RECEIPT DATE: 11/6/15 **ONSITE SEWAGE DISPOSAL SYSTEM** P 5 57448

PROPERTY ADDRESS: 11030 Fuzzy Hollow Way, Marriottsville, MD

BAT Plan
Low Pressure Dosing System Report

SITE PLAN FOR BAT INSTALLATION

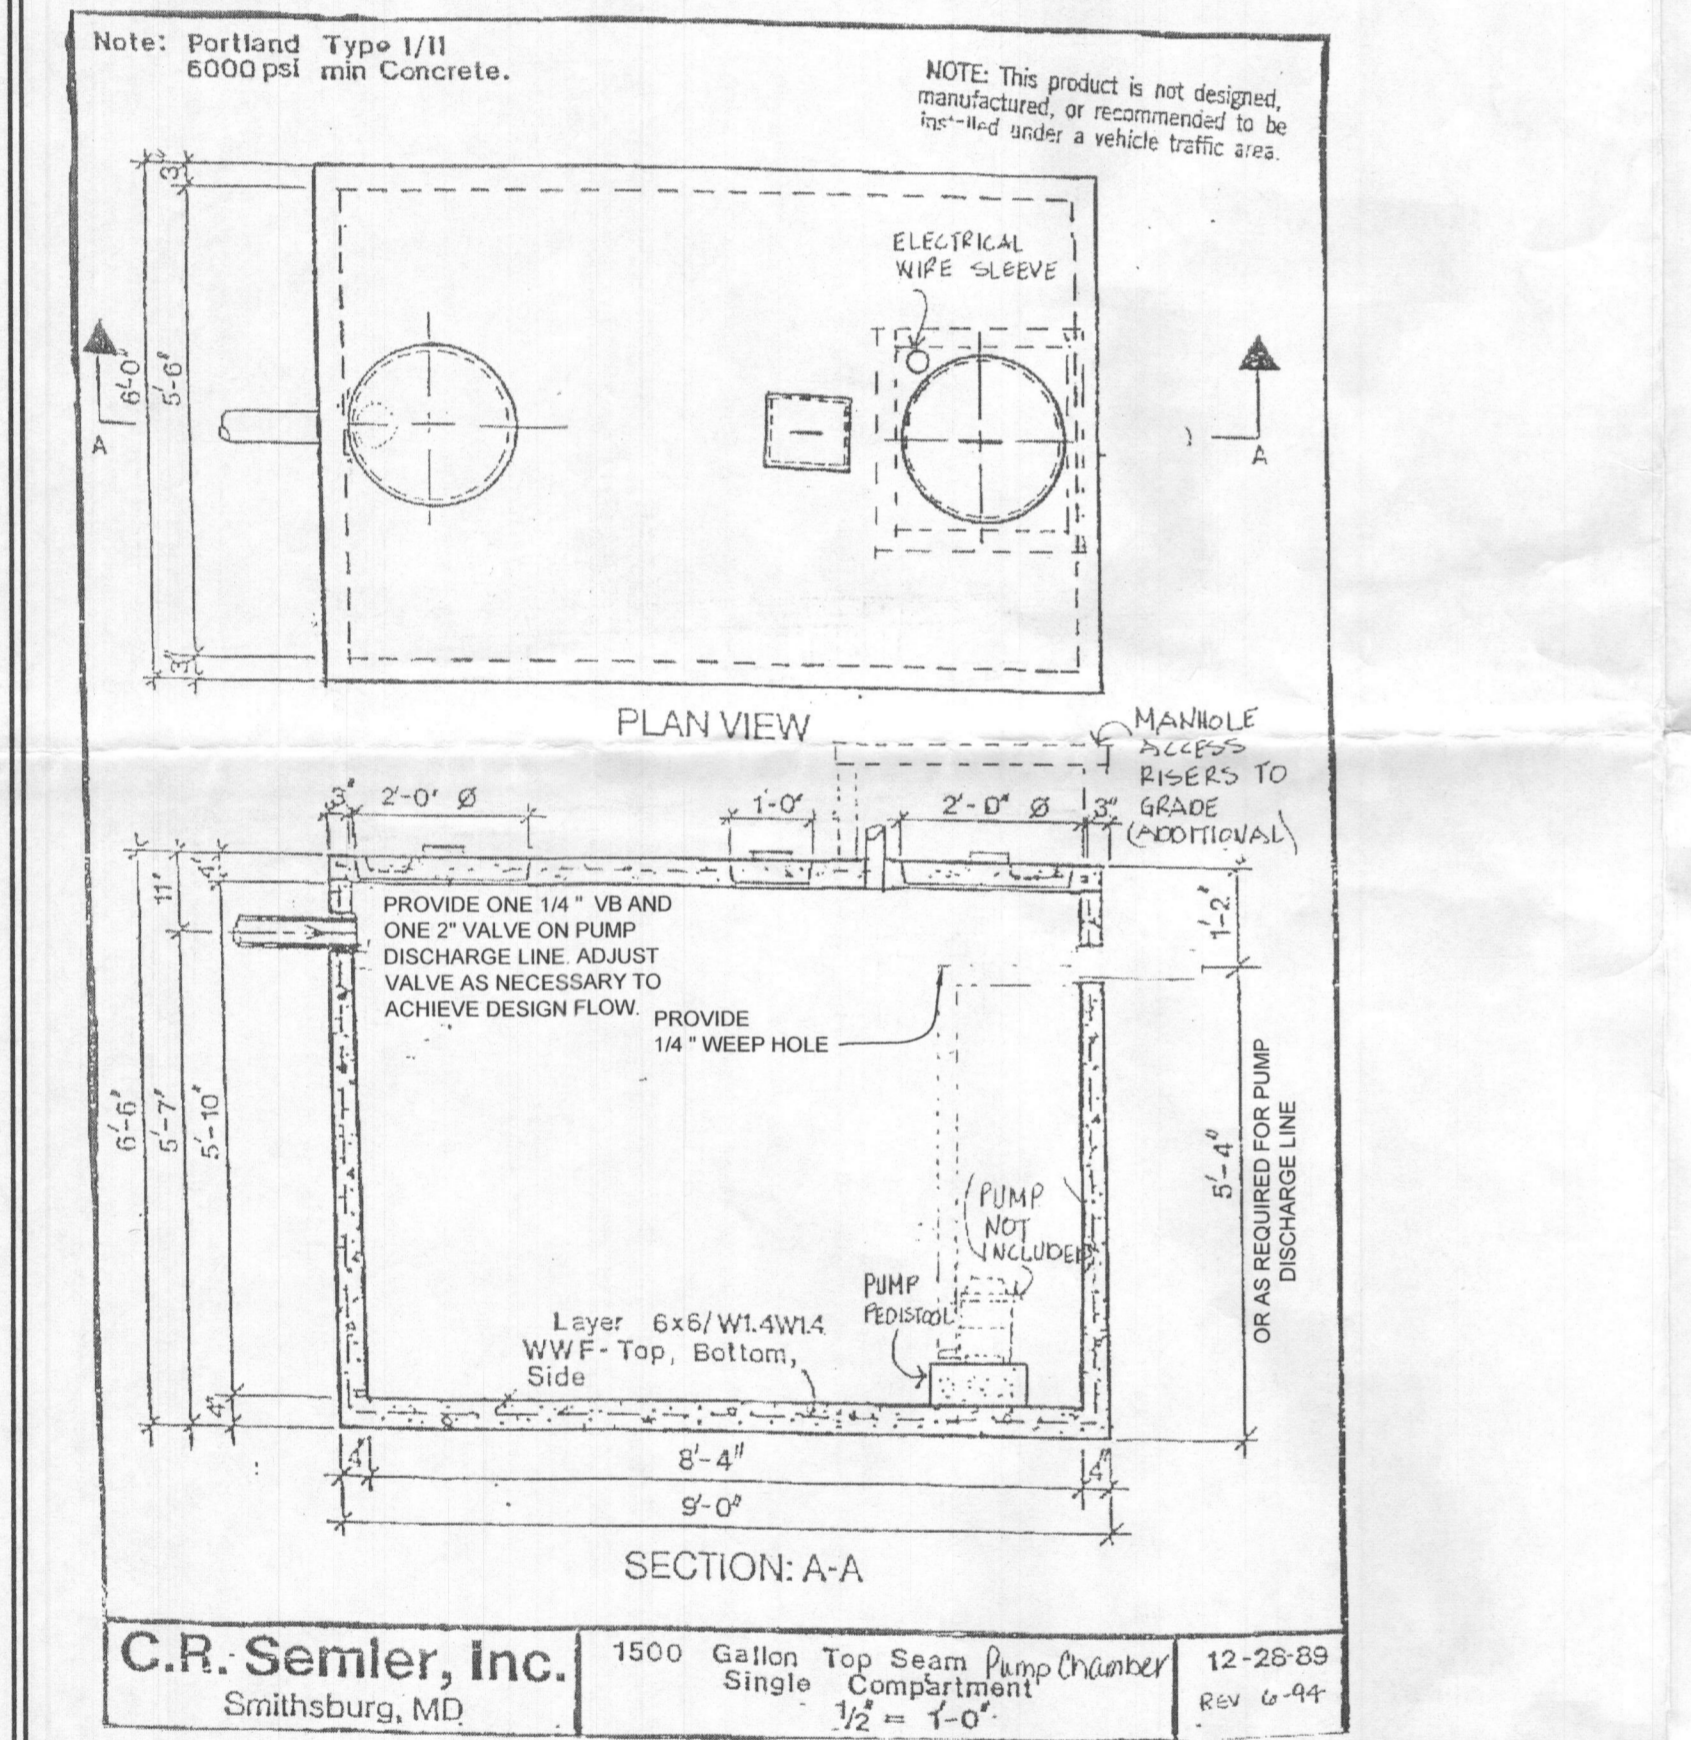
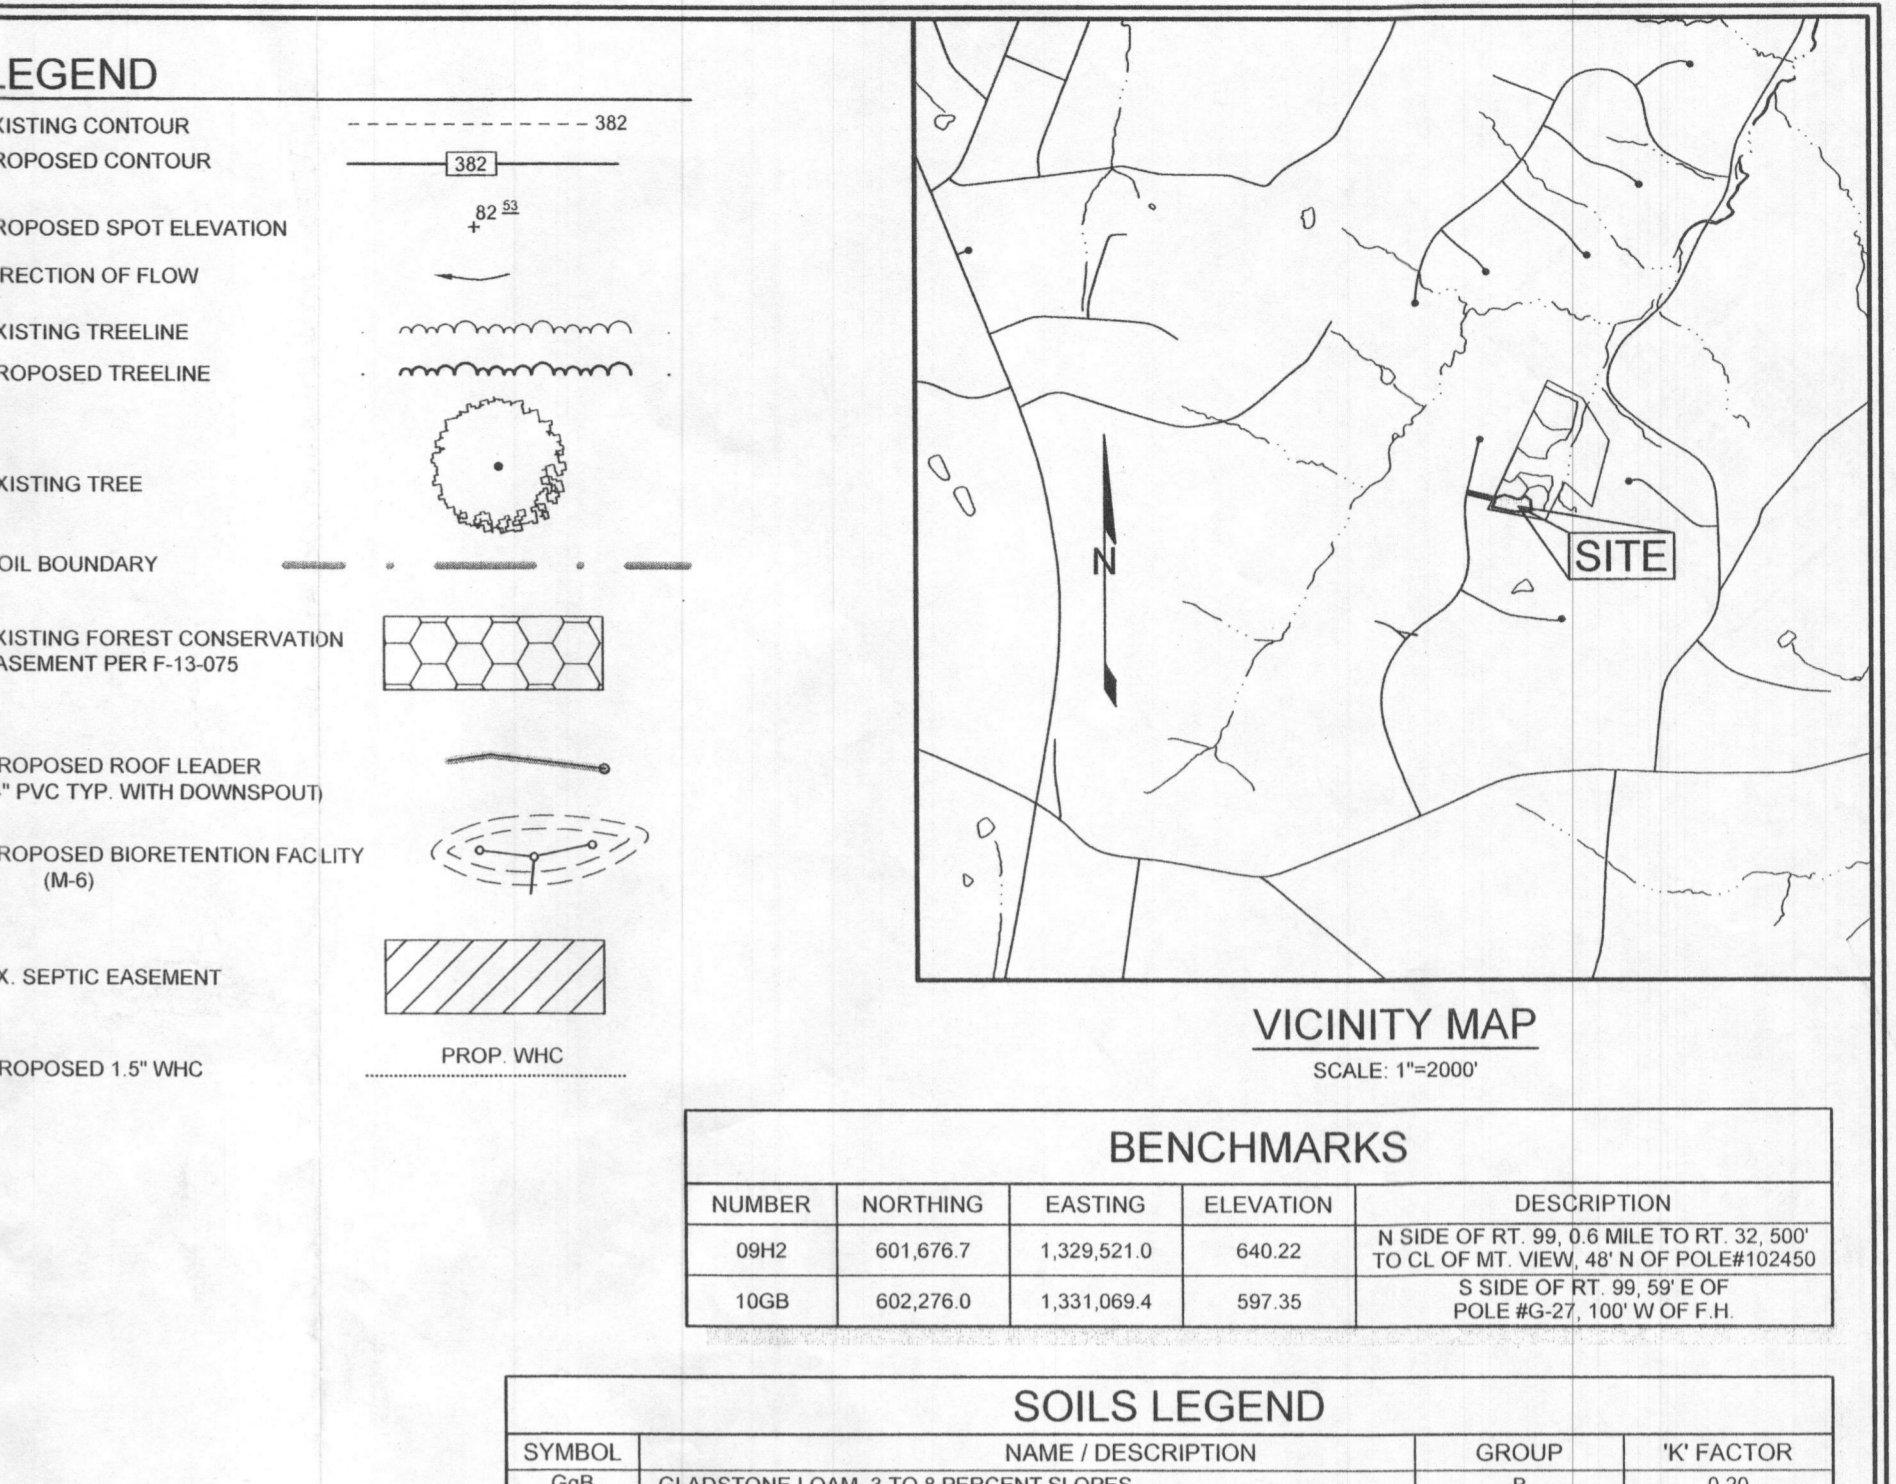
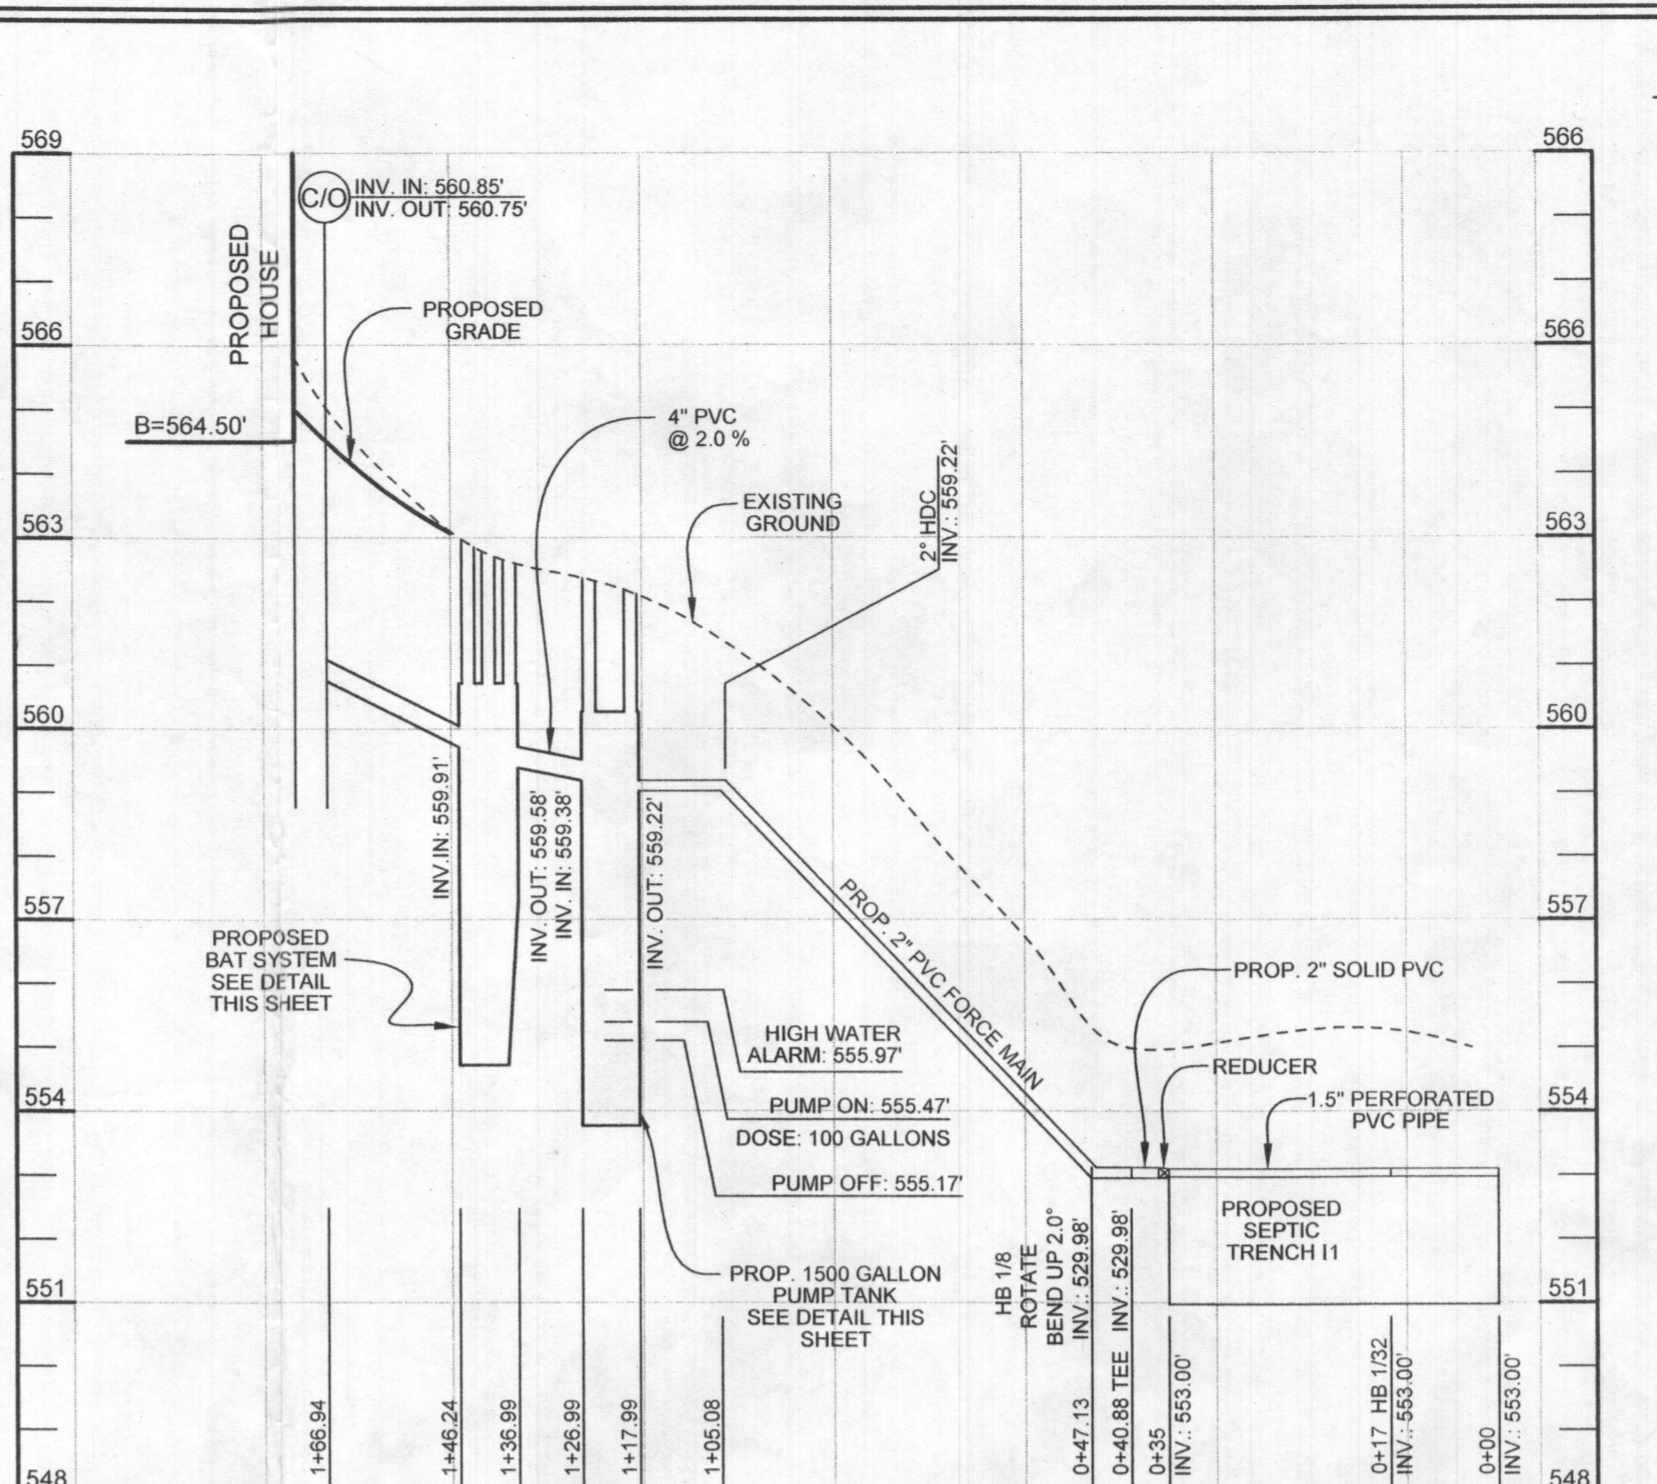
I've reviewed the BAT plan for 11030 Fuzzy Hollow and see one issue in need of correction. On the LPD design chart, you list the lateral length as 52' for both laterals, but the true lateral length will be a ½ hole space shorter than that. The rest of the chart is accurate. The correct lateral length for lateral 1 is 48.75' and for 2 is 49.1'. Would you like to revise or do you want me to redline it? Thanks

I've reviewed the BAT plan for 11030 Fuzzy Hollow and see one issue in need of correction. On the LPD design chart, you list the lateral length as 52' for both laterals, but the true lateral length will be a ½ hole space shorter than that. The rest of the chart is accurate. The correct lateral length for lateral 1 is 48.75' and for 2 is 49.1'. Would you like to revise or do you want me to redline it? Thanks

Thanks for catching that. You can make that change.
